OTIF/RID/NOT/2015

Notification

1 January 2015 edition of RID

Texts adopted by the 53rd session of the RID Committee of Experts (Berne, 22 May 2014)

Figure 3.4.7.1

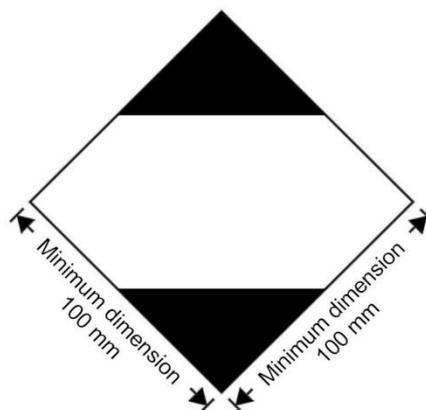
"3.4.7 Marking for packages containing limited quantities

3.4.7.1 Except for air transport, packages containing dangerous goods in limited quantities shall bear the marking shown in Figure 3.4.7.1:

3.4.7.2 If the size of the package so requires, the minimum outer dimensions shown in Figure 3.4.7.1 may be reduced to be not less than 50 mm × 50 mm provided the marking remains clearly visible. The minimum width of the line forming the diamond may be reduced to a minimum of 1 mm.

Figure 3.4.8.1

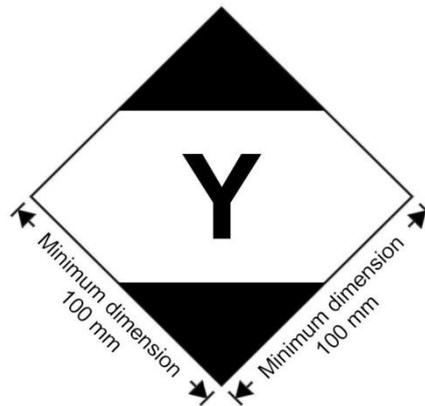
3.4.8 Marking for packages containing limited quantities conforming to Part 3, Chapter 4 of the ICAO Technical Instructions

3.4.8.1 Packages containing dangerous goods packed in conformity with the provisions of Part 3, Chapter 4 of the ICAO Technical Instructions may bear the marking shown in Figure 3.4.8.1 to certify conformity with these provisions:

3.4.8.2 If the size of the package so requires, the minimum outer dimensions shown in Figure 3.4.8.1 may be reduced to be not less than 50 mm × 50 mm provided the marking remains clearly visible. The minimum width of the line forming the diamond may be reduced to a minimum of 1 mm. The symbol "Y" shall remain in approximate

proportion to that shown in Figure 3.4.8.1."

Figure 3.5.4.2

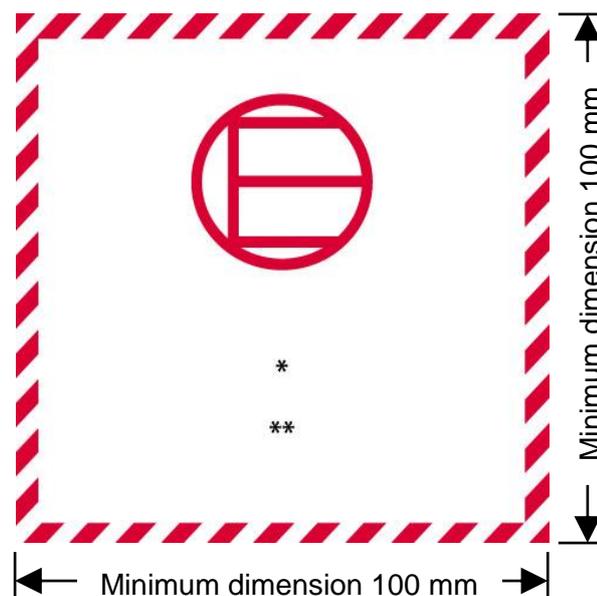
3.5.4.2 Amend to read as follows:

"3.5.4.2 Excepted quantities mark

Figure 5.2.2.2.1.1

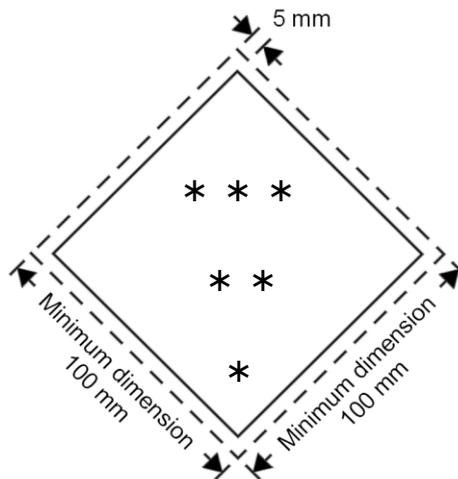
5.2.2.2.1.1 Amend to read as follows:

"5.2.2.2.1.1 Labels shall be configured as shown in Figure 5.2.2.2.1.1.

Figure 5.3.1.7.1

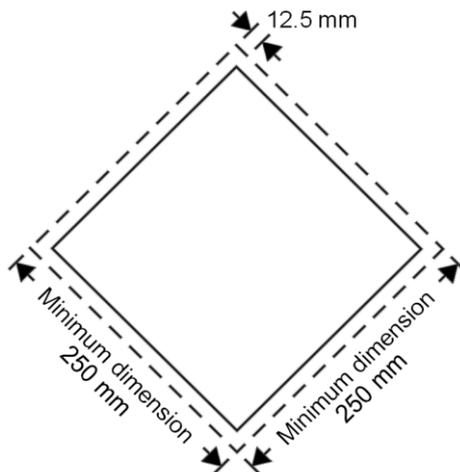
5.3.1.7.1 Amend read as follows:

"5.3.1.7.1 Except as provided in 5.3.1.7.2 for the Class 7 placard, and in 5.3.6.2 for the environmentally hazardous substance mark, a placard shall be configured as shown in Figure 5.3.1.7.1.

Figure 5.3.3

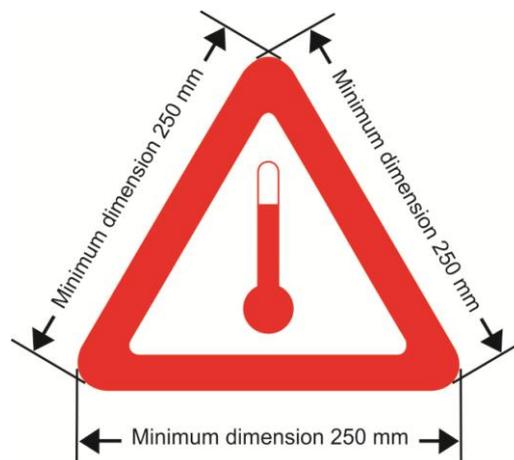
"5.3.3 Elevated temperature substance mark

Tank-wagons, tank-containers, portable tanks, special wagons or large containers or specially equipped wagons or large containers containing a substance that is carried or handed over for carriage in a liquid state at or above 100 °C or in a solid state at or above 240 °C shall bear on both sides for wagons, and on both sides and at each end for large containers, tank-containers and portable tanks, the mark shown in Figure 5.3.3.

Figure 5.5.2.3.2

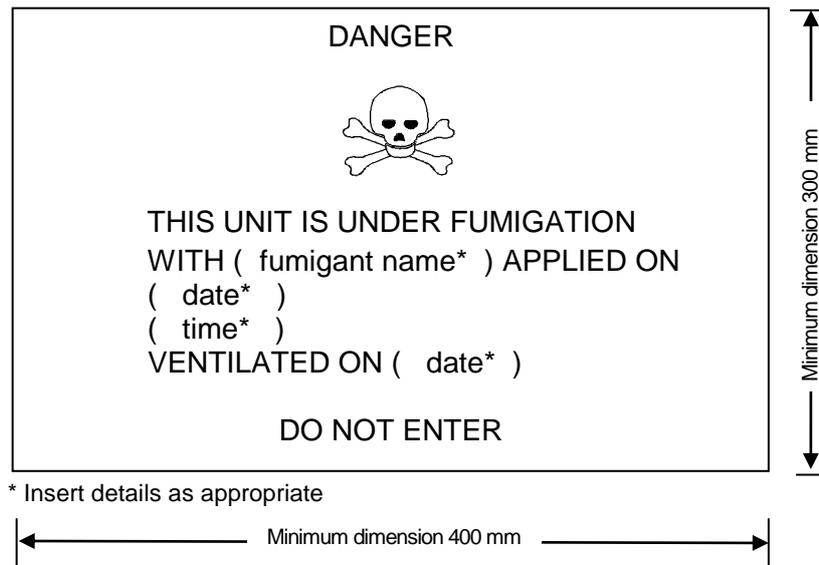
5.5.2.3.2 Amend to read as follows:

"5.5.2.3.2 The fumigation warning mark shall be as shown in Figure 5.5.2.3.2.

"Figure 6.5.2.2.2.1

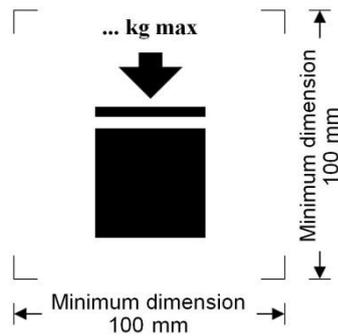
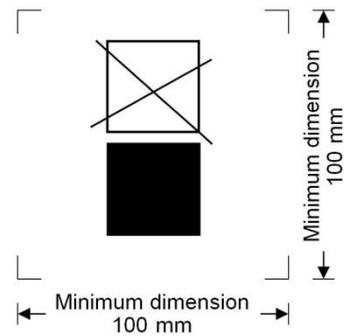
6.5.2.2.2 Amend to read as follows:

"6.5.2.2.2 The maximum permitted stacking load applicable when the IBC is in use shall be displayed on a symbol as shown in Figure 6.5.2.2.2.1 or Figure 6.5.2.2.2.2. The symbol shall be durable and clearly visible.

"Figure 6.6.3.3.1

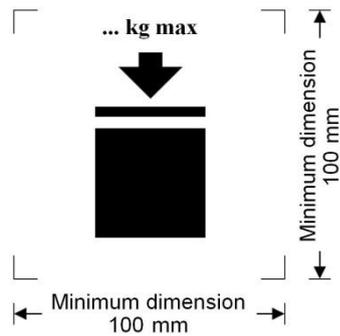
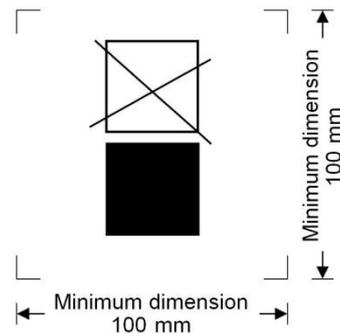
"6.6.3.3 The maximum permitted stacking load applicable when the large packaging is in use shall be displayed on a symbol as shown in Figure 6.6.3.3.1 or Figure 6.6.3.3.2. The symbol shall be durable and clearly visible.
